PD Modification Application: MM 24-0034

Proposed MM 24-0034: The proposed Major Modification requests to amend the conditions of approval for PD 92-0366, that has had no subsequent amendments in the intervening +/- 32 years since its 1992 adoption. The applicant proposes an Option #2 to allow up to 136,000 square feet of non-residential uses including Office and Retail uses fronting SR 674, with a Mini-Warehouse building located in the northeast quadrant of the site.

AGENCY REVIEW COMMENT SHEET

8.2 Proposed Site Plan: Option 1 (Full)

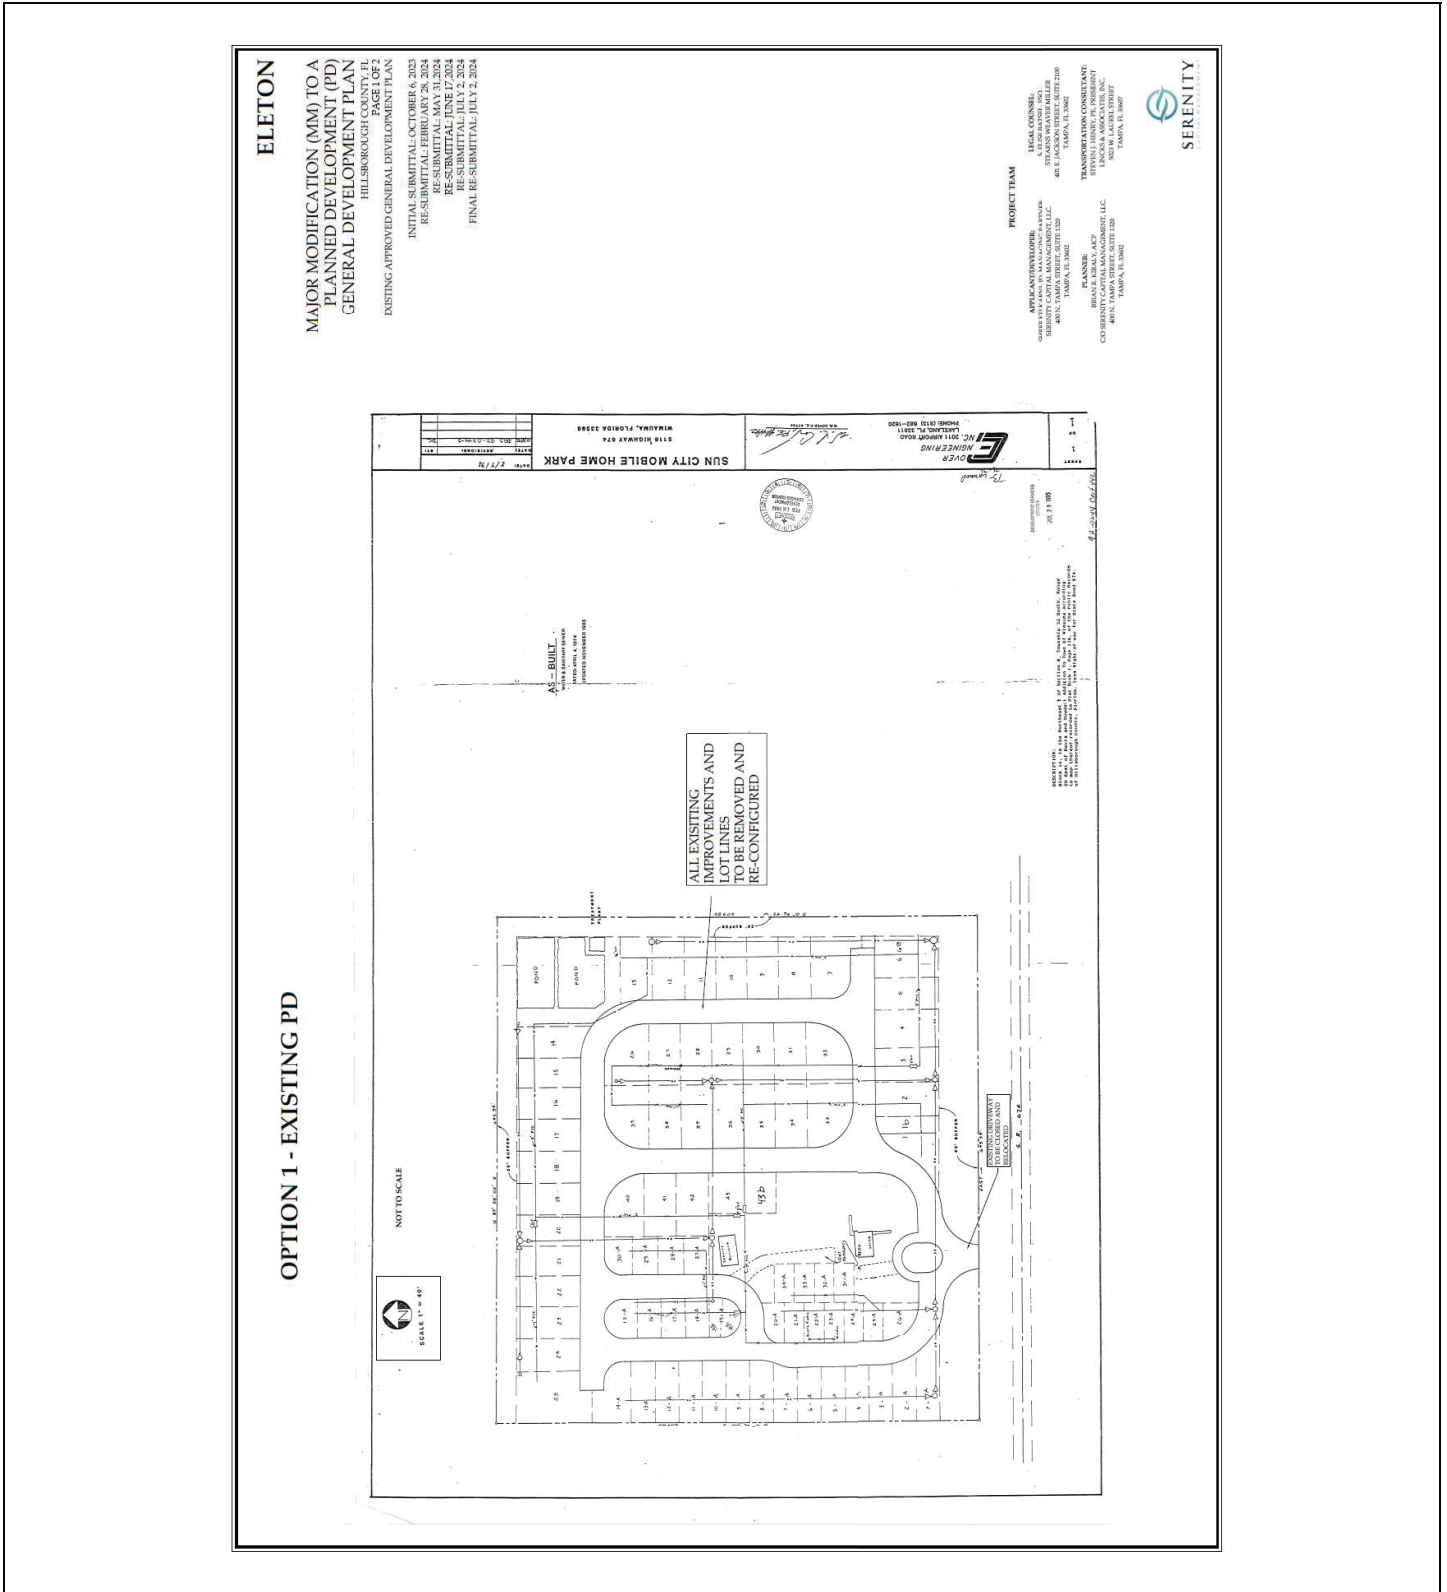
Prior to Site Plan Certification the following shall be amended:

- Remove “All Existing Improvements and Lot Lines to be Removed and Re-configured” on Option 1 Site Plan.
- Remove “Existing Driveway to be Closed and Relocated” on Option 1 Site Plan.

- Revise the “0’ – 20’ Building Setback” to “0’ – 10’ Setback” for the Office / Retail fronting SR 674.
- Revise “PD PRS PD 92-0366” to “PD 92-0366”
- Remove the blank box to the left of the notes.

- Modify site note # 17, “RIGHT-OF-WAY RESERVATION/DEDICATION: AREAS OF RIGHT-OF-WAY (ROW) RESERVATION ARE SHOWN ON THIS PLAN TO ALLOW FOR THE FUTURE WIDENING OF SR 674 TO 126' ROW. ADDITIONAL ROW DEDICATION PROPOSED FOR THE PROJECT ENTRANCE AT 58', AND THE NORTH-SOUTH AND EAST-WEST GRID ROADS AT 47', A SHOWN.”

- Add a double headed arrow on the eastern boundary with a label that states “The adjacent property may take access to the roadway subject to County Standards and Requirements.”

Required Public Transit Facilities

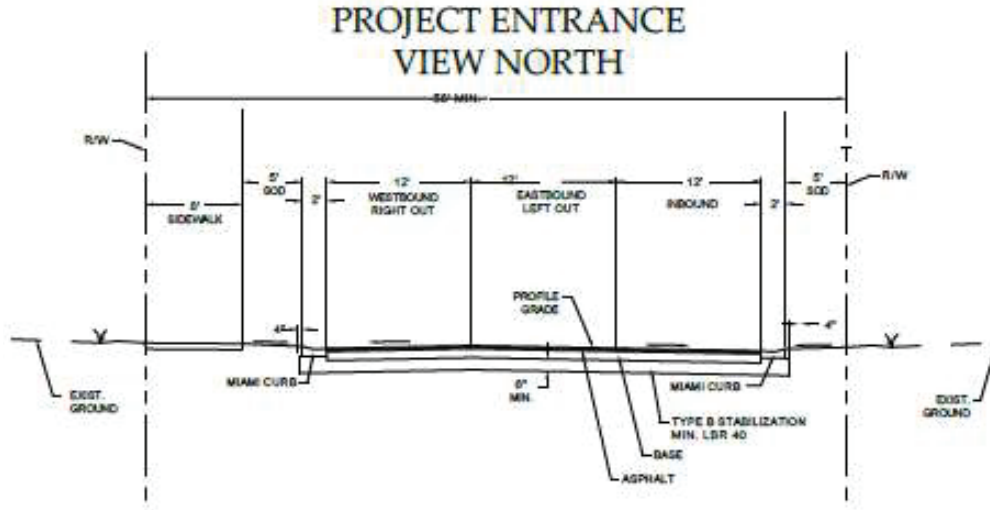
As required by Sec. 6.03.09.C.3. of the LDC, the developer shall construct a transit accessory pad and bus shelter, which shall include seating, a trash receptacle and bicycle rack in accordance with Hillsborough Area Regional Transit (HART) design standards. Notwithstanding anything herein these conditions or on the PD site plan to the contrary, the final location of the facility will be determined at the time of plat/site/construction plan review and is subject to approval of Hillsborough County and HART.

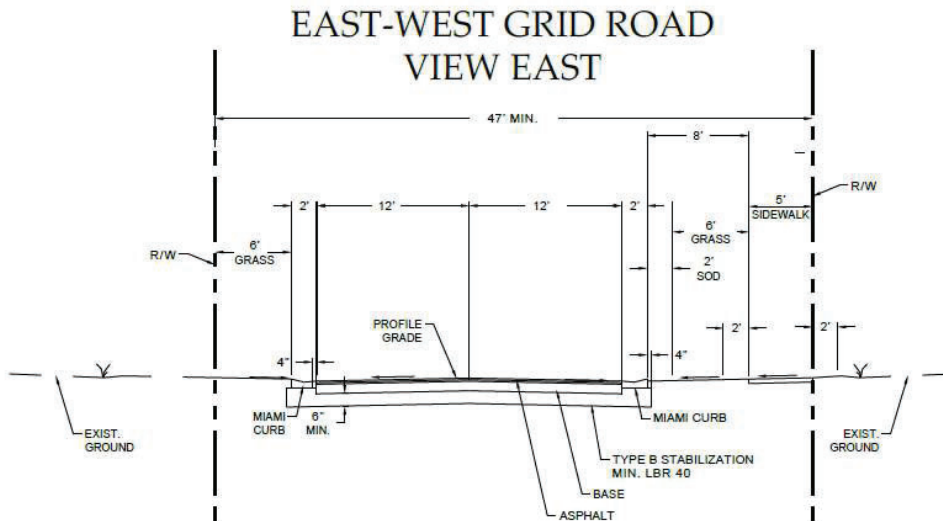
The remaining section of the North-South roadway consists of two 12-foot lanes and a 5-foot sidewalk on the westside within a total 47 feet of right of way. This segment will intersect with the proposed East-West roadway.

The East-West roadway will provide connectivity between the North-South roadway and the future extension of the grid to the east and west upon redevelopment of the adjacent properties, who will be responsible for constructing their respective segments. The section consists of two 12-foot lanes and a 5-foot sidewalk within 47 feet of right of way. See proposed section below.
